## ADDENDUM No. 1

**Re: Our Lady of Fatima CES Renovations WCDSB**  
**Consultant No.: 23-035**  
**RFT No.: 2024-04**

**Demolition Floor Plan A103**

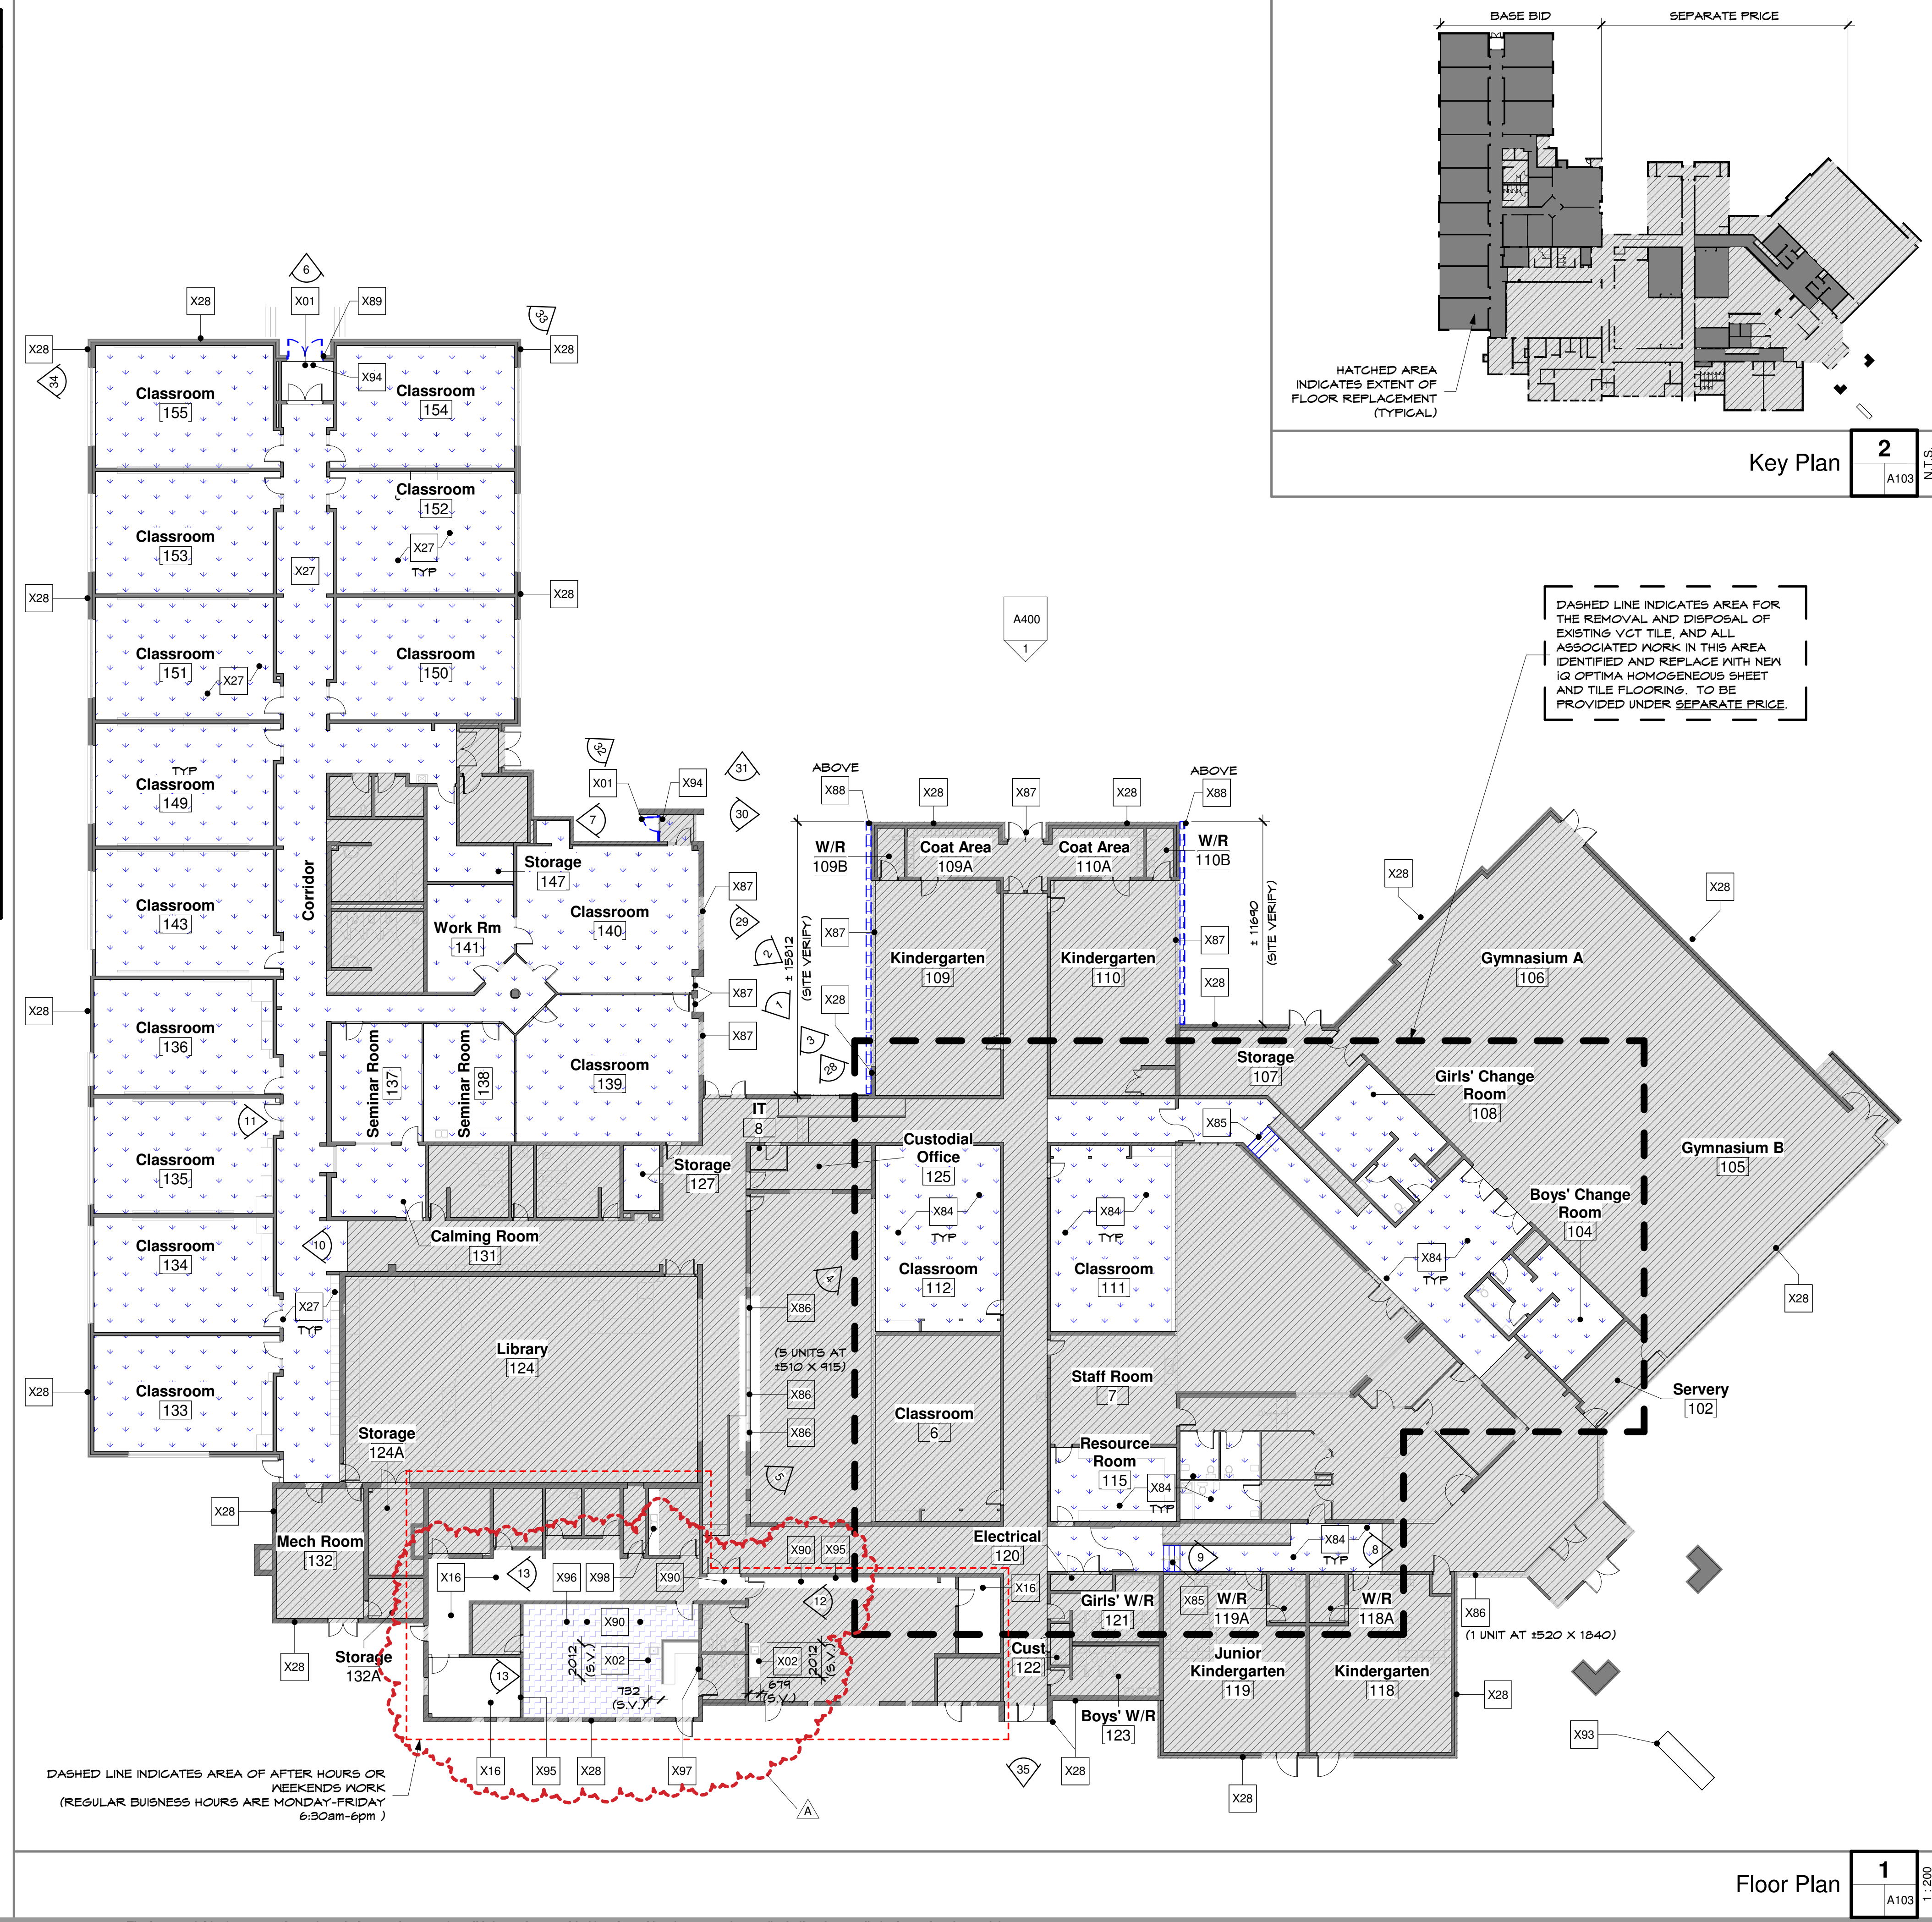
Revise: Refer to the attached revised Architectural drawings sheets A103 and A201 for revised clouded additional scope of work at the daycare area that will be required to take place after hours.
